Technical Memorandum

To:	Kathy Arnold	From:	Amy L. Hudson, REM
Company:	Rosemont Copper Company	Date:	November 23, 2010
Re:	Rosemont Infiltration, Seepage, Fate and Transport Response to Comments	Doc #:	268/10-320884-5.3
CC:	David Krizek. P.E.; Mark Williamson (Tetra Tech)

ATTACHMENT 1
TECHNICAL REVIEW OF INFILTRATION, SEEPAGE,
FATE AND TRANSPORT MODELING REPORT, TETRA
TECH, 2010, PREPARED FOR ROSEMONT COPPER
COMPANY (SRK, 2010)

Illustration 1.0 Modified Particle Size Distribution

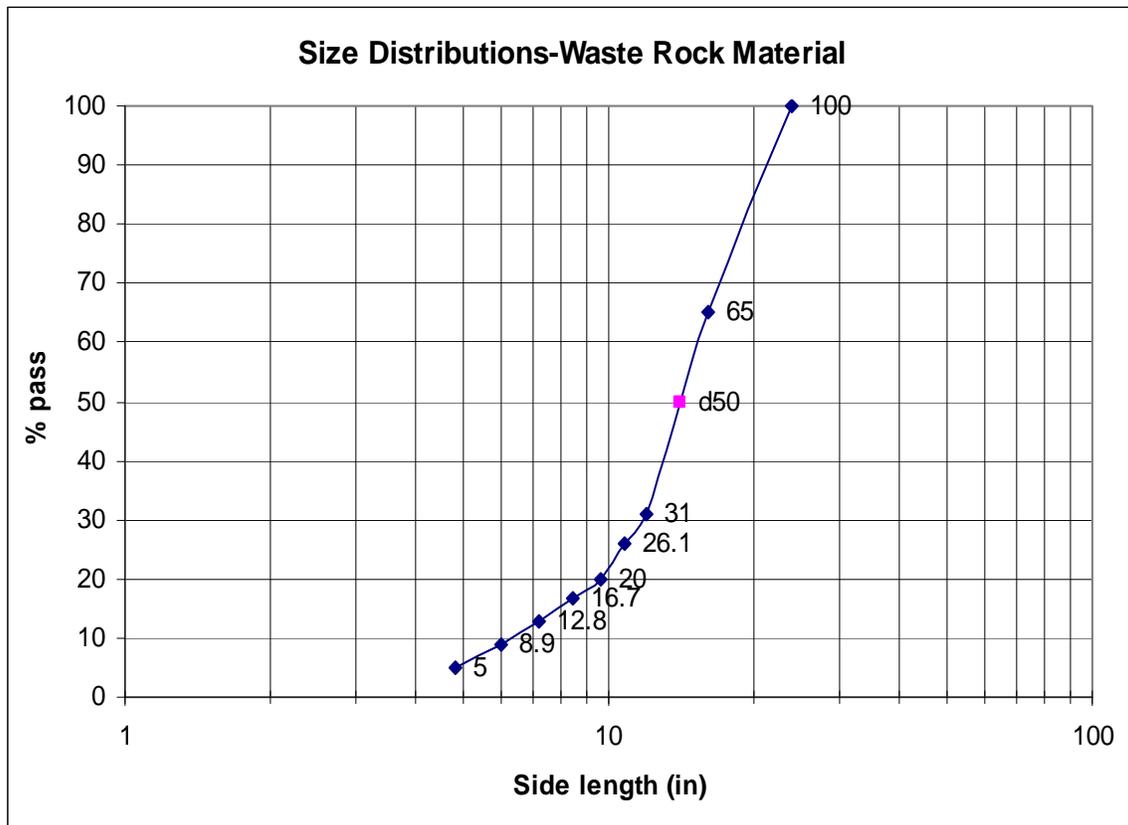
1. *Consider the impacts of leaching the oxide material and its impact on the hydraulic conductivity and the use of a run of mine material property to model the heap.*

- 2. The draindown rate seems to underestimate the time that will be required to reach a rate of ten gallons per minute and will require management during and after reclamation.*

In May of 2009, the document titled *Rosemont Heap Leach Facility Permit Design Report* (Tetra Tech, 2009b) was submitted to the Arizona Department of Environmental Quality (ADEQ) as part of a submittal for the Aquifer Protection Permit (APP) application associated with the Rosemont Project. The design plans indicated two (2) pads, cumulatively able to accommodate

up to about 75 million tons (Mt) total: 40 Mt on the Phase 1 Pad and 35 MT on the Phase 2 Pad. Based on a 2008 in-fill drilling program conducted by Rosemont, and as presented in a 2009 Feasibility Update, approximately 69,000 Mt of oxide ore have been delineated. The ore density has an assumed density of 125 pounds per cubic foot (pcf).

Based on Appendix F of the May 2009 design report - Design Criteria (Tetra Tech, 2009b), run-of-mine (ROM) ore will be placed on the pad. Estimated ROM particle size distributions were determined for the Rosemont deposit by Call & Nicholas, Inc. (CNI, 2008). CNI calculated four (4) fragment size-distributions for the ore and waste rock materials in the Rosemont Open Pit. The fragment size-distributions included sulfide ore, oxide ore, and two (2) waste rock types. Subsequent analysis performed in conjunction with designing the flow-through drain structures (Technical Memorandum titled *Rosemont Flow-Through Drain Design* (Tetra Tech, 2010c) dated April 5, 2010) determined that the ROM waste rock is anticipated to have a D50 of about 14" with 80% of the rock materials under 24" in diameter (see Illustration 1.0 below). The oxide ore is anticipated to have a similar distribution.

As described in the response above, the material being placed on the heap leach pad will be ROM sized material. Based on the gradation presented in Illustration 1, the ROM material includes few fines and will generally have a high saturated hydraulic conductivity. The type of material anticipated to be placed in the heap is also not expected to breakdown and generate a significant amount of fines due to the chemical leaching. Because of the lack of fines and high saturated hydraulic conductivity, the heap leach will drain freely after leaching operations cease. A review of conditions at other heap leach pads currently in closure or post-closure in Arizona and Nevada support the conclusion of the draindown rate reaching approximately ten (10 gallons per minute within a three (3) year period.

Figure 1 Example of soil water characteristic curve (SWCC)

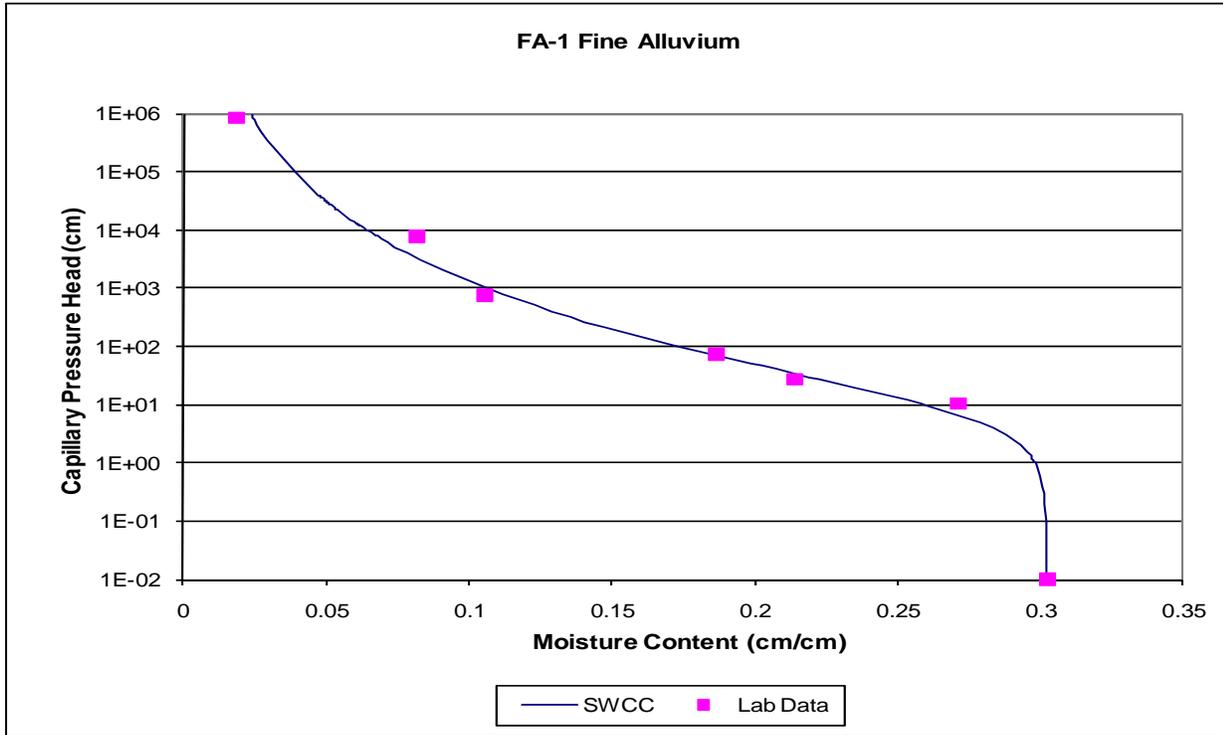
Section 5.3 of the report provides an explanation of unsaturated flow theory. Illustration 5.5 shows a generic soil water characteristic curve (SWCC) for two soils, however, an illustration of hydraulic conductivity as a function of capillary function or moisture content is not presented or discussed. Section 5.5.5 presents saturated hydraulic conductivity values for three waste rock materials, alluvium, and bedrock without providing either a range of values, or a source for the saturated hydraulic conductivity data.

Illustrations of the hydraulic conductivity and water content functions were added to the descriptions of input parameters provided in Sections 5.5.5.1 through 5.5.5.5 of the updated report (Tetra Tech, 2010b).
